PROJECT: Sky View Pines - update #7

CITY OF LAS VEGAS INTER-OFFICE MEMORANDUM			DATE: August 29, 2012	
TO: Land Development Services Department of Public Works			FROM: Albert Sung, P.E. Flood Control Project Engineer Department of Public Works	
SUBJECT:		Drainage Study for:		COPIES TO: L. R. Nelson Consulting Engineers Nevada H.A.N.D. Bart Anderson, P.E., DevCo CNLV
Sky View Pines – Update #7				
Cross Streets:	SWQ of Owens Avenue & Main Street			
File Number:	F:\Depot\DSMemos\DS4315K.doc			
Parcel Number:	139-27-502-003			
Zoning Action:	SDR-28121			
FEMA Flood Zone	YES	NO	X	
Proposed Storm Drain	YES	NO	X

**UPDATE #7 TO THE
TECHNICAL DRAINAGE
STUDY FOR
SKY VIEW PINES**

**Re: Update #7 to the Technical Drainage Study for Sky View Pines
(DS4315)**

OWNER
CITY OF LAS VEGAS
15 W. OWENS AVENUE
LAS VEGAS, NEVADA 89106

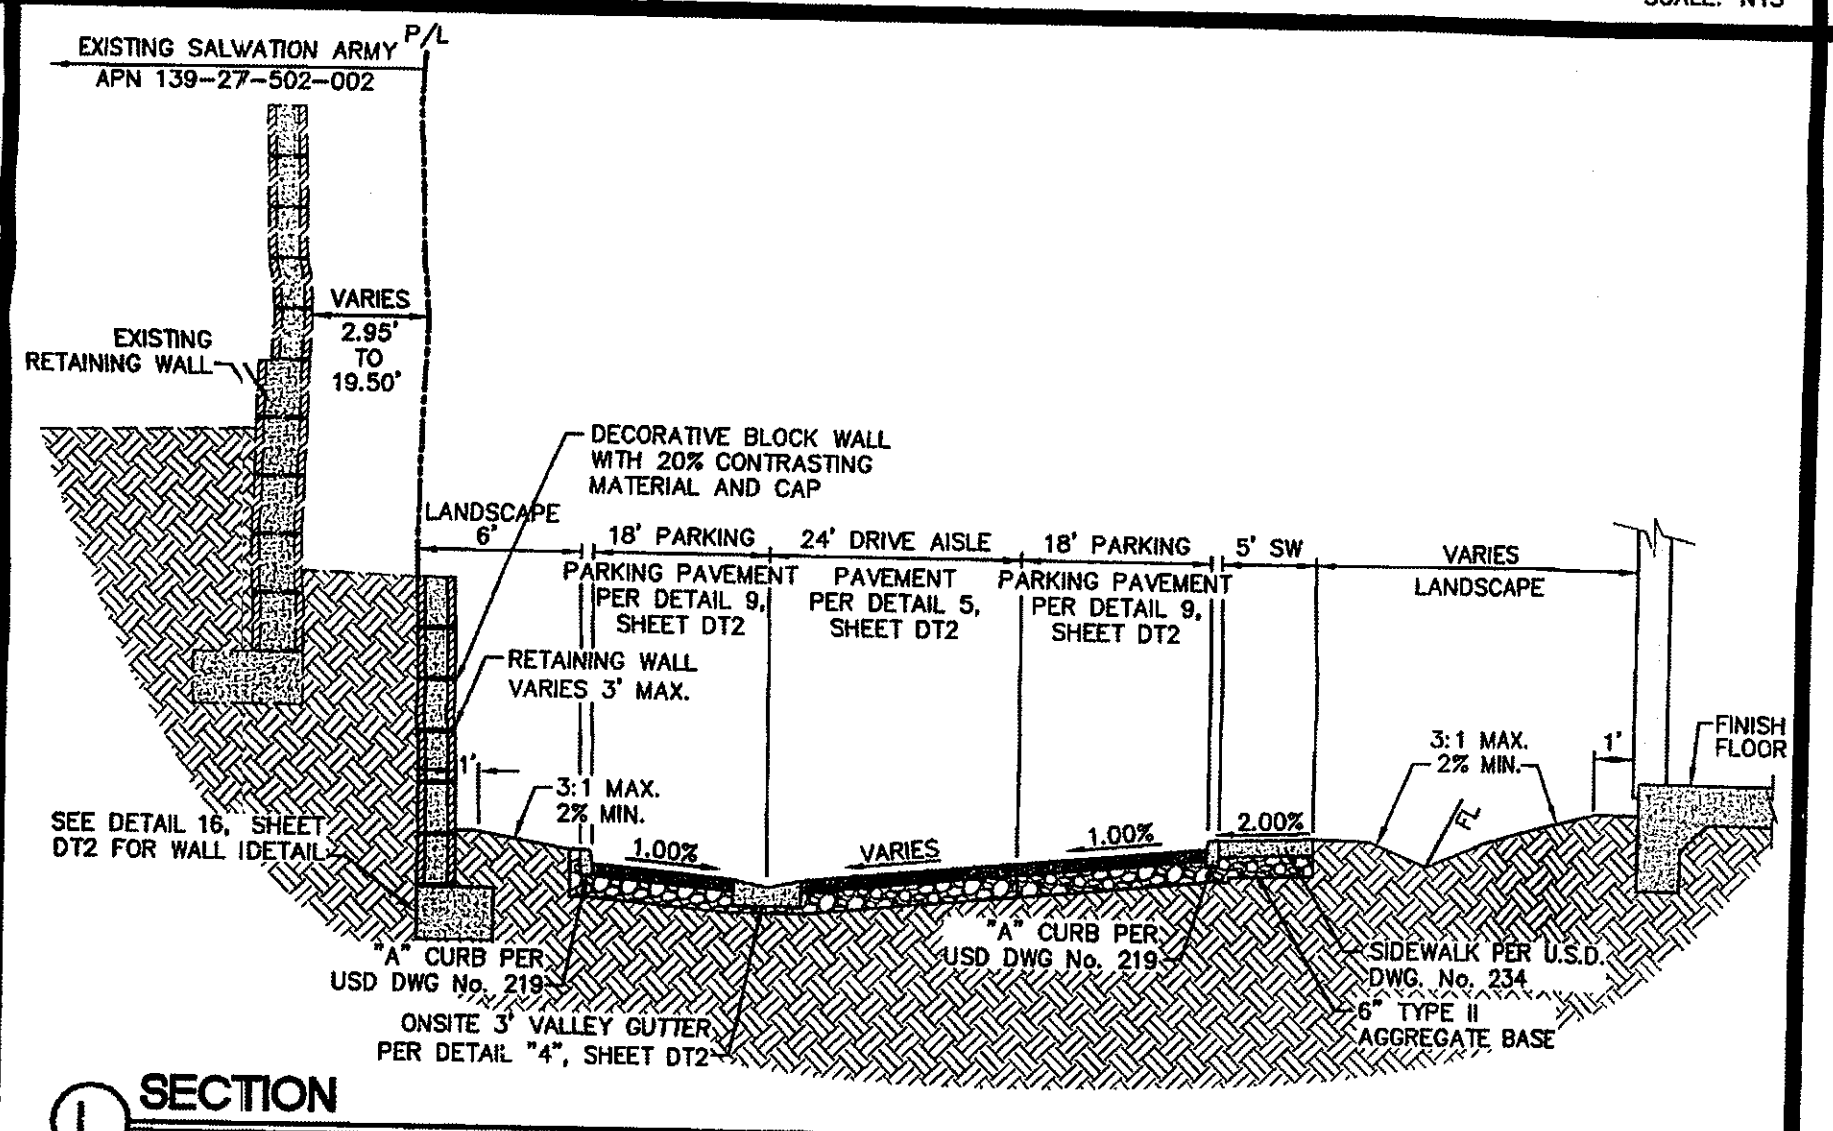
1. **Sheet GR2:** Revise a typo error of finished grade elevation at the southwest corner of the proposed "Activity Building" from 29.25 FG to "**39.25 FG**".
